AUSTIN CITY COUNCIL AGENDA

ITEM No. 43

Subject: C814-06-0106 - 208 Barton Springs - Conduct a public hearing and approve an ordinance amending Chapter 25-2 of the Austin City Code by rezoning property locally known as 208 Barton Springs Road (Town Lake Watershed) from commercial-liquor sales-neighborhood plan (CS-1-NP) combining district zoning and lake commercial-neighborhood planning (L-NP) combining district zoning to planned unit development-neighborhood plan (PUD-NP) combining district zoning. Staff Recommendation: To grant planned unit development-neighborhood plan (PUD-NP) combining district zoning with conditions. Planning Commission Recommendation: To grant planned unit development-neighborhood plan (PUD-NP) combining district zoning with conditions. Applicant and Agent: Graves, Dougherty, Hearon & Moody, P.C. (Michael Whellan). City Staff: Jorge E. Rousselin, 974-2975.

ZONING REVIEW SHEET**CASE:** C814-06-0106**P. C. DATE:** August 8, 2006
August 22, 2006
October 10, 2006
October 24, 2006
November 14, 2006
November 28, 2006**ADDRESS:** 208 Barton Springs Road**OWNER:** 208 Barton Springs (Glenn Jones)**AGENT:** Graves, Dougherty, Heaton &
Moody, P C (Michael Whellan)**

EXHIBIT 'A'

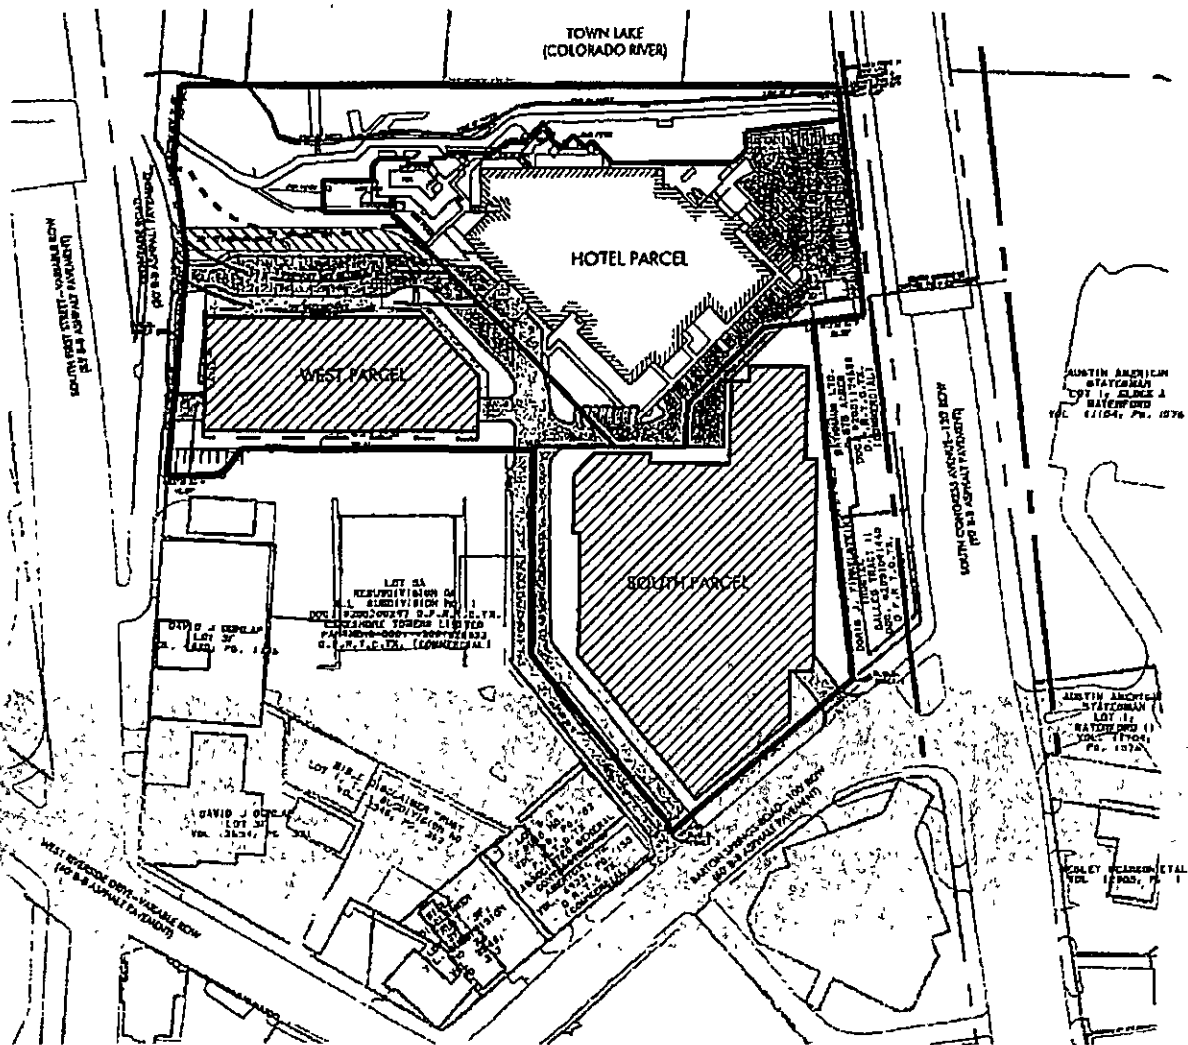
- SP 1. The proposed PUD would be required to comply with the Waterfront Overlay, South Shore sub district regulations.
- SP 2. Describe and show on the land use plan the type of existing and proposed residential uses per tract/parcel and/or phase, including maximum density (if multi-family development is proposed, maximum FAR, maximum height, minimum lot size and width, and any other site development requirements deemed appropriate [Sec. 25-2-411(H)]

- SP 8 Describe the type of existing and proposed residential uses per tract and/or phase, including maximum density (if multi-family development is proposed, maximum FAR, maximum height, minimum lot size and width, and any other site development requirements deemed appropriate [Sec. 25-2-411(H)] Show on land use plan

- SP 10 For all non-residential development provide a summary table indicating the site development regulations for each existing and proposed use by tract and/or phase. Uses shall be listed at a level of detail sufficient for Traffic Impact Analysis review as required in Section 25-6. Include the following information [Sec 25-2-411(I)]: Show on land use plan

1. On Exhibit AZI (Area Zoning Map), we have corrected the zoning for the tract adjacent to the above-referenced property from "LI-NP" to "L-NP".
2. On SP1 (Detailed Land Use Plan), pursuant to staff's comments, we have shown and calculated open space and setbacks for each of the parcels; and
3. Although Danny Miller, P.E. is still the engineer working on the project, he has changed firms and, therefore, the engineering firm has been changed on all of the exhibits to reflect that it is now LJA Engineering & Surveying, Inc.
